**Re: AI-Faisal College, Austral (SSD-10445)**

Submission for Al-Faisal College Austral (SSD-10445)

Figure 1.1 – Proposed Road Variations

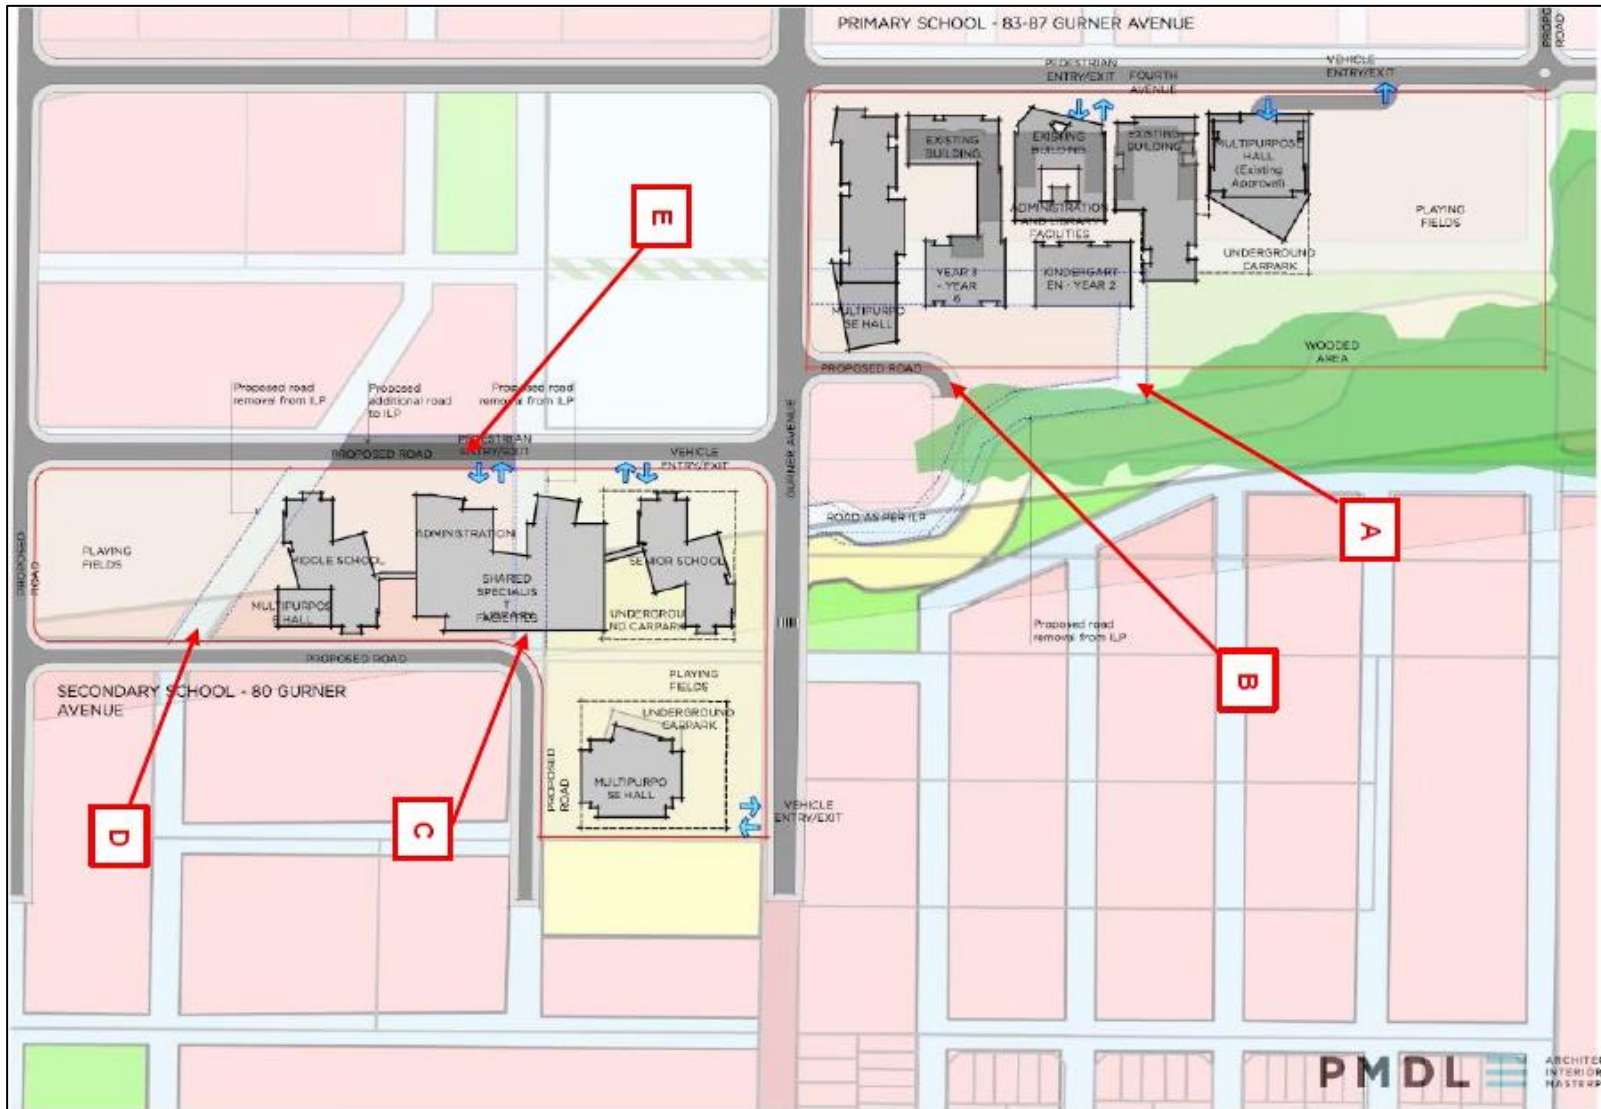
Proposed Road Variation	Support Yes/No	Comment
Road A	No	<p>Road A is proposed to be deleted as part of this SSD application. Council has exhibited a draft ILP (18 March 2020 to 21 April 2020) to remove a road to the west of the Road A as part of Liverpool Local Environmental Plan – Amendment to SEPP (Sydney Region Growth Centres) 2006.</p> <p>The proposed removal of the road west of Road A is justified given that the school is established and has buildings in the area indicated for a future road.</p> <p>Road A as proposed by the draft ILP is designed to allow the remaining lands to be developed and allow for passive surveillance to the future public open space. This further variation to the ILP as proposed by this SSD is not supported.</p> <p>The variation as proposed will result in a strip of land that can only be developed in a manner which has its back and/or side to the open space, further reducing passive surveillance and public safety concerns relating to the space. This will restrict access to the open space, and is not considered orderly development, nor an optimal outcome.</p> <p><b>Please note</b> - Attachment 2 further explains the proposed amendments to the ILP i.e. by Council as part of a separate amendment process and the applicants' proposed changes as part of the SSD Application.</p>

Road B	No	<p>Road B is proposed as a variation to the deletion of Road A. The proposed variation would restrict access to the open space, and is not considered orderly development or an optimal outcome.</p> <p>The proposed amendment does not encircle the remainder of the residential zoned land outside of the school, in fact it isolates a long narrow (20-40m wide) strip of R3 zoned land between the school and open space, which would only have access to a road on its southern boundary. This strip of land could only be developed in a manner which has its back and/or side to the open space, thus further reducing passive surveillance and public safety concerns relating to the future open space.</p>

Proposed Road Variation	Support Yes/No	Comment
		<p>Whilst there may be an opportunity to provide a pedestrian and cycle path between the school and the open space, this would be facilitated on neighbouring land. However, this shifts the burden of providing a public benefit to another landowner, who receives no benefit in providing such infrastructure.</p> <p>This proposed ILP change will not provide for the orderly development of adjacent land, and will reduce passive surveillance to the public open space when compared to the recently exhibited ILP.</p> <p>A variation to the proposed ILP as exhibited is not supported.</p>
Road C	No	<p>The proposal does not consider precinct permeability at the neighbourhood scale. The proposed deletion of Road C creates a barrier to the pedestrian desire line. The road variation is not in keeping with the principles of maintaining pedestrian permeability along desire lines in close proximity to a town centre.</p> <p>Other existing planned school sites (within the Austral ILP) creates large landholdings whilst also maintaining permeability - this proposal proposes the deletion of local roads which dramatically reduces permeability.</p> <p>The 'diversion' for pedestrians from the east of the proposed school to the (yet to be built) neighbourhood centre is not modest. If pedestrian/s were walking from the street corner on the eastern side of Road C and travelling to the neighbourhood centre on the western extent of Road C, this represents a distance of approximately 150m; a 300m return trip could be completed in about 4 minutes. By removing Road C and D, one would then have to travel around the perimeter of the school, via new road E.</p> <p>This is approximately 650m, resulting in a 1.3km return trip which would take &gt;15 minutes (walking at the same speed). This would significantly impact on the desirability for active transport, either decreasing local sales / commercial viability or increasing demand on parking and traffic around the centre. This is not consistent with the objectives of creating liveable neighbourhoods and encouraging sustainability in the South West Growth Area. A variation to the proposed ILP as exhibited is not supported.</p>

Road D	No	<p>In addition to points raised above in Road C, it is recognised that non-ninety-degree roads are not ideal, however the angled road still provides permeability.</p>

Proposed Road Variation	Support Yes/No	Comment
		<p>Road D also provides the most direct link between two planned public open space areas. It is recommended that this road is retained.</p> <p>A variation to the proposed ILP as exhibited is not supported.</p>
Road E	No	<p>The addition of this road could be supported from the standpoint that it increases permeability, however, it is entirely located on a neighbouring allotment. This shifts the burden onto the neighbouring allotment.</p> <p>Without agreement from the neighbouring property owner, Council staff cannot support the proposed amendment.</p>

If DPIE supports any or all of the above road layout variations, agreement should be obtained from the affected and adjoining property owners prior to any approvals given.

Figure 2.1 - Explanation of Proposed Changes (map source Planning Ingenuity Ptd Ltd).

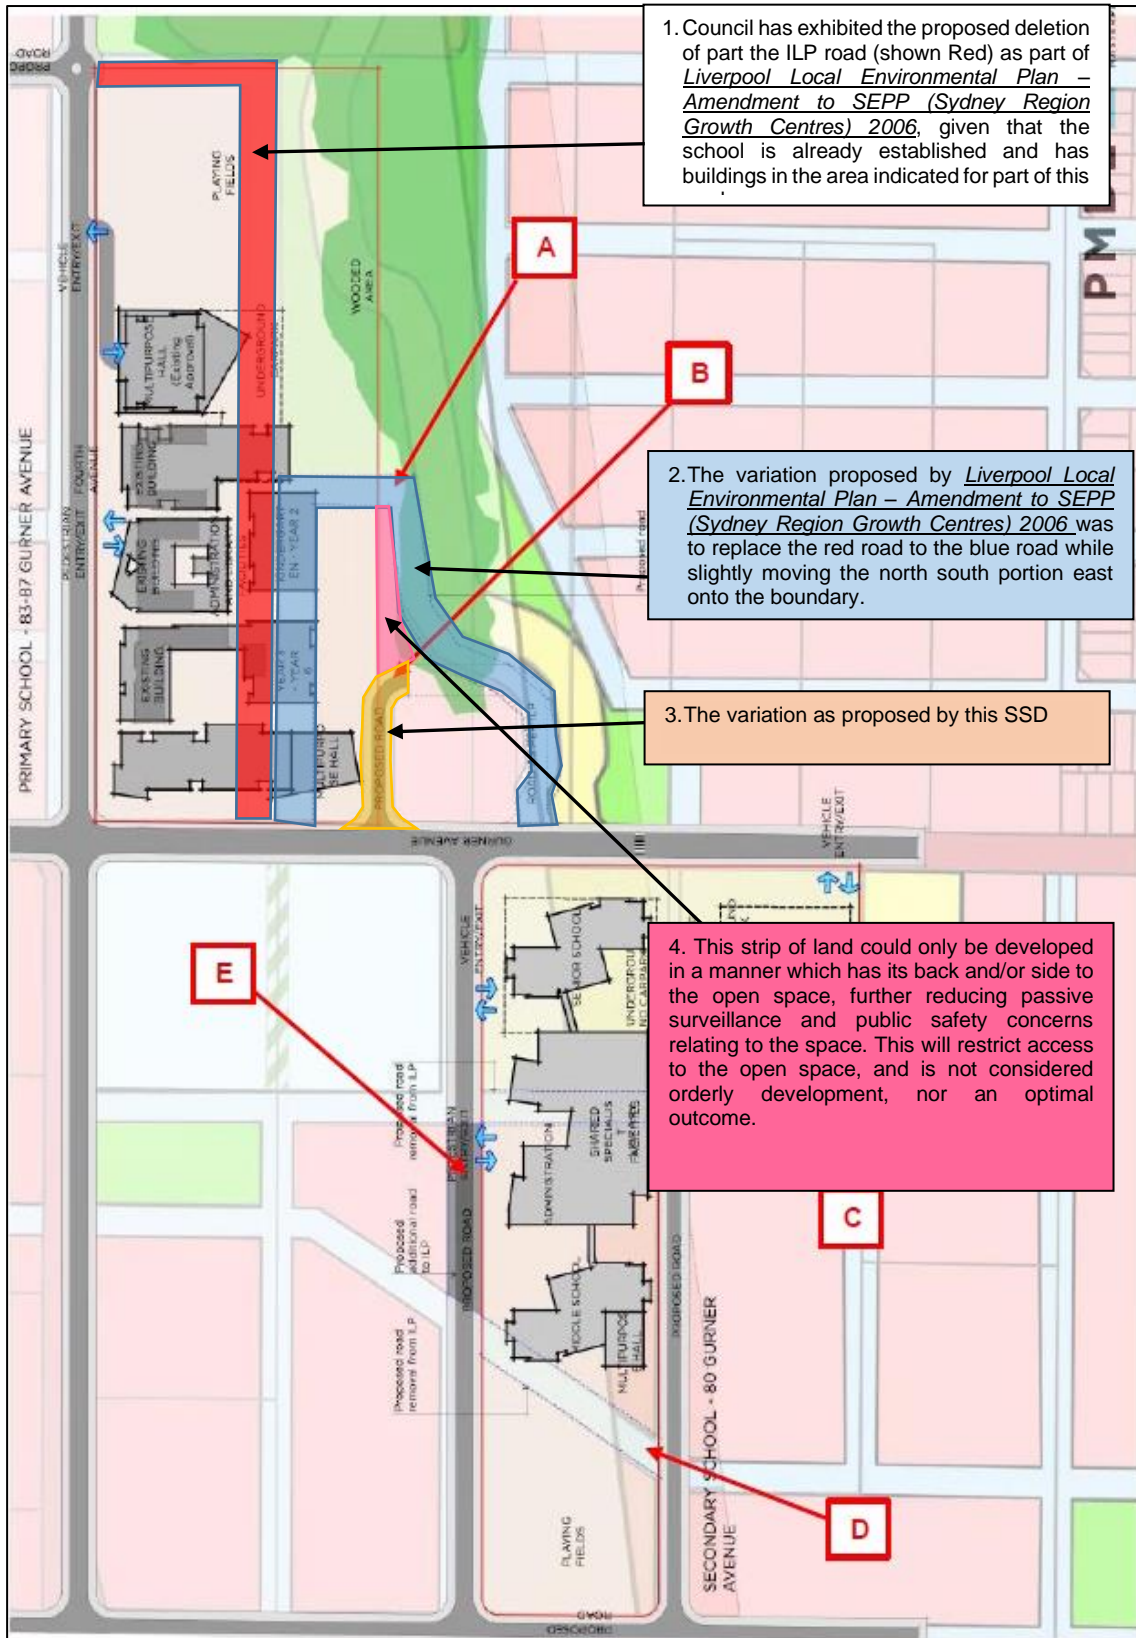
1. The *Liverpool Local Environmental Plan – Amendment to SEPP (Sydney Region Growth Centres) 2006* proposes to delete the (red) road shown in Figure 2.1 below.

2. The *Liverpool Local Environmental Plan – Amendment to SEPP (Sydney Region Growth Centres) 2006* proposes to replace the red road to the blue road while slightly moving the north south portion east onto the boundary.

4. The applicant made a submission on *Liverpool Local Environmental Plan – Amendment to SEPP (Sydney Region Growth Centres) 2006* proposing a loop road.
